TOLEDO - LUCAS COUNTY PLAN COMMISSIONS

REF: SUP-2004-24

SUBJECT: Special Use Permit for a New Gas Station at 1405 Bernath Parkway (South-East Corner of Airport Highway and Bernath Parkway)

LANDSCAPE PLAN

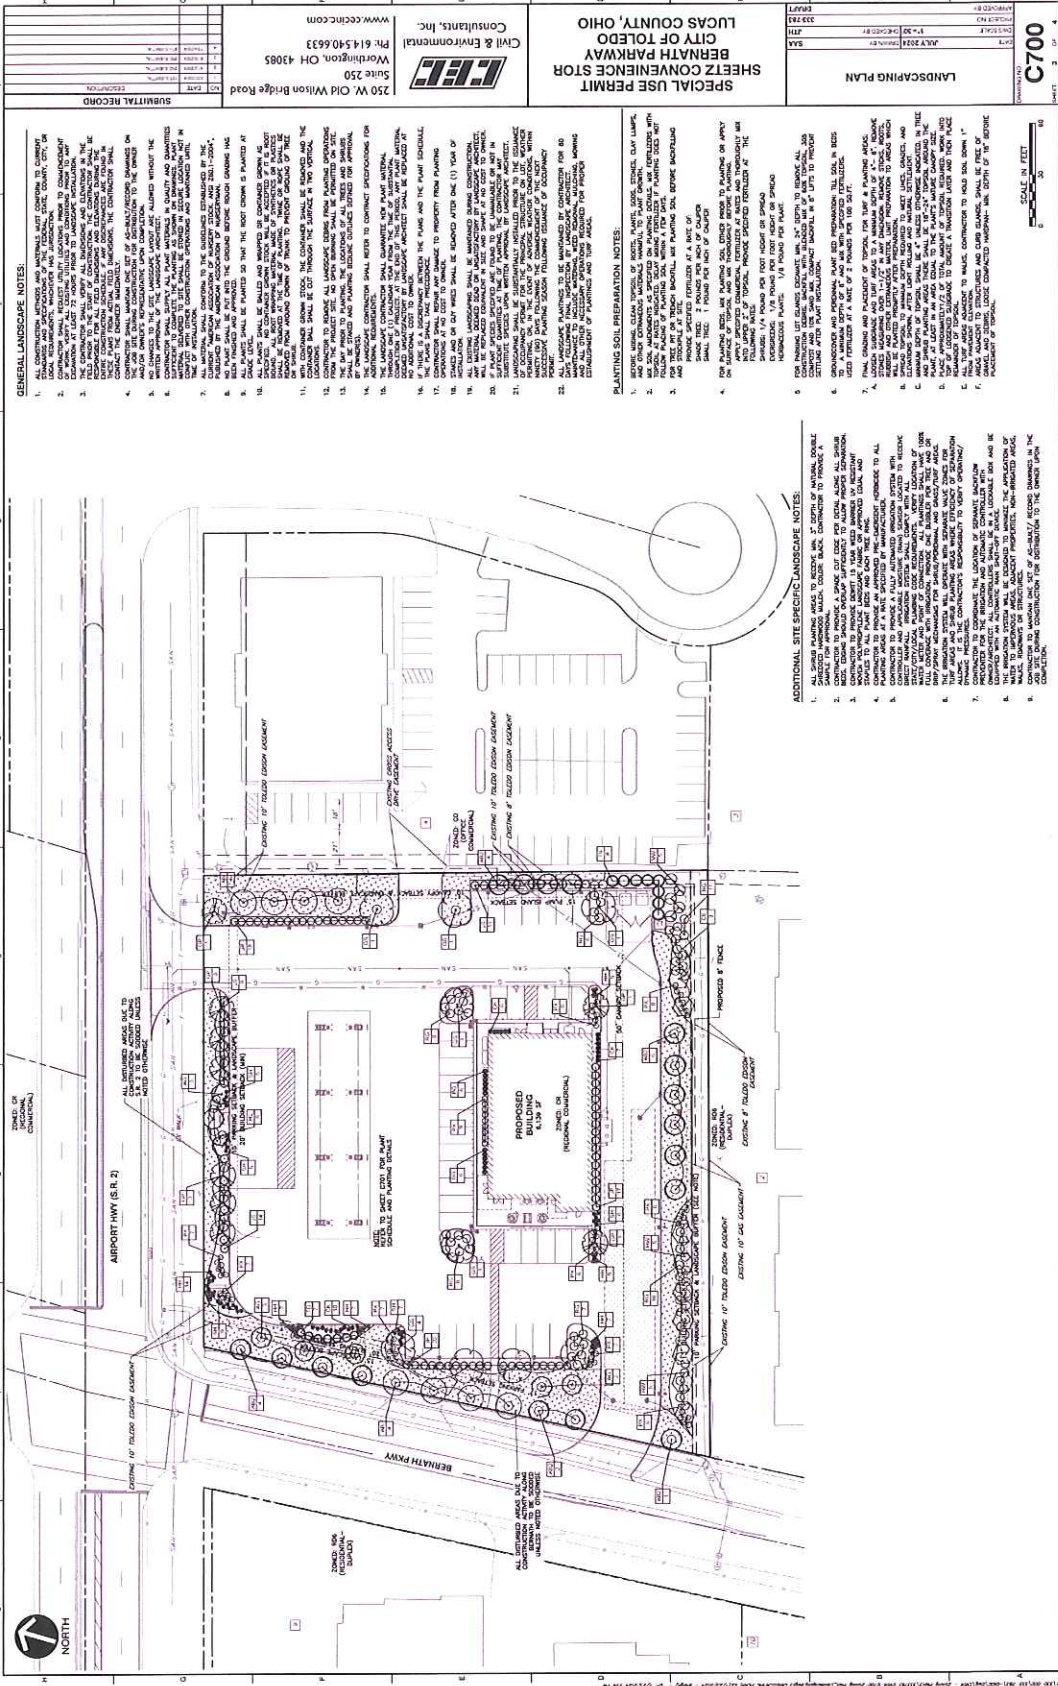
An extensively landscaped frontage greenbelt is required along all public rights-of-way. At least one tree must be provided for every thirty feet (30') of lot frontage, rounded up. The lot has ±305 feet of frontage on Bernath Pkwy and ±275 feet of frontage on Airport Hwy, requiring eleven (11) trees and ten (10) trees respectfully. The site plan provides eleven (11) trees along Bernath Pkwy and ten (10) trees along Airport Hwy. This is acceptable; however, a solid evergreen hedge is required to screen parking in the front of the property and prevent headlights from being seen from the right-of-way. There are two gaps in the evergreen hedge screening which are likely to cause headlights to be visible from Bernath Parkway. The applicant will need to submit a revised landscape plan removing these gaps.

A perimeter landscape buffer is required along the parking lot visible from the property to the east – along the eastern property line. One (1) canopy tree must be provided for each thirty (30) linear feet, plus a continuous shrub with a minimum height of eighteen inches (18”). The parking lot abutment along the eastern property line is ±236 linear feet, requiring eight (8) canopy trees. The landscape plan shows eight (8) trees with a continuous shrub. This is acceptable as depicted.

In addition to the other landscape requirements for buffer areas and frontage greenbelts, one (1) tree is required for every 1,000 square feet of building coverage and two (2) canopy trees and six (6) shrubs are required for each ten (10) parking spaces. The proposed building is 6,139 square feet and the parking lot has fifty-six (56) parking spaces, meaning nineteen (19) trees are required. Sixteen (16) are provided on the landscaping plan. Three (3) additional trees are required and must be shown on a revised landscaping plan.

- d. Two (2) canopy trees and six (6) shrubs are required to be installed in interior landscape areas for each ten (10) parking spaces within the parking lot. A total of twelve (12) trees and thirty-six (36) shrubs are required for this site. **Not acceptable as depicted. Only eleven (11) trees provided. See condition 45(f).**

- e. One 2-inch caliper tree for every 1,000 square feet of building coverage shall be required. Seven (7) trees are required for this site. **Not acceptable as depicted. Only five (5) trees provided. See condition 45(f).**

- f. The interior site landscaping is missing three (3) required trees. These additionally required trees may be placed anywhere on the site. **Approval of a final landscaping plan will be upon the discretion of the Planning Director.**

CANOPY DETAILS

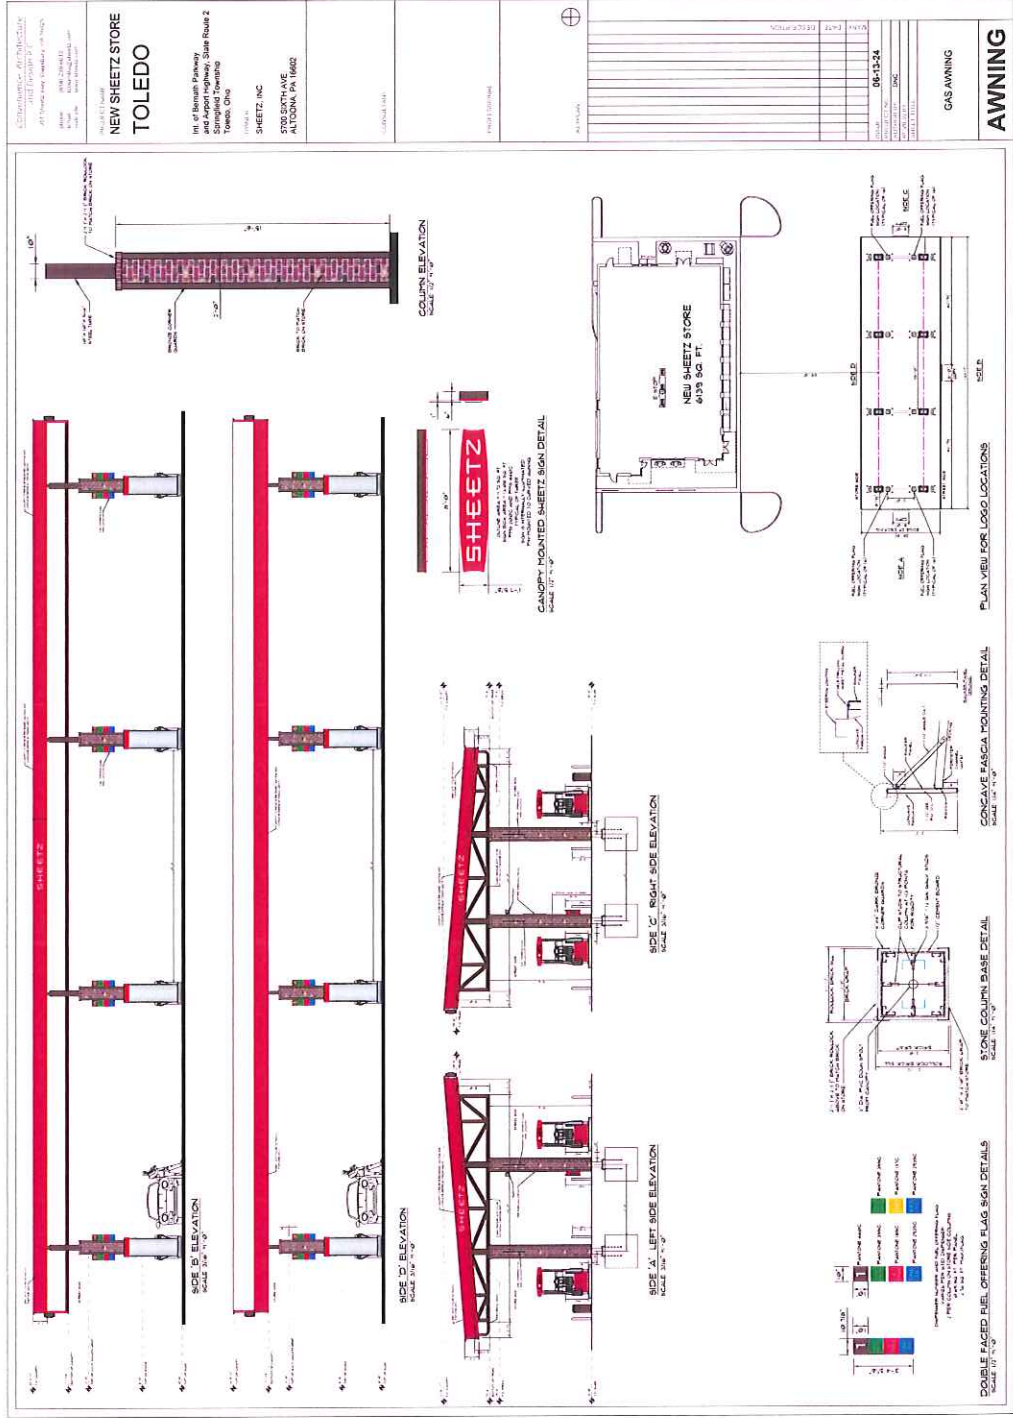
Support columns must be brick or stone compatible with the principal building per TMC§1104.0903(A). This brick or stone finish must span the entire column up to the canopy. The submitted canopy elevations are acceptable as depicted.

50. Canopy support columns must be brick or stone which is compatible with the principal building's brick or stone. Canopies shall consist of that material for its entire length up to the canopy. **Acceptable as depicted.**
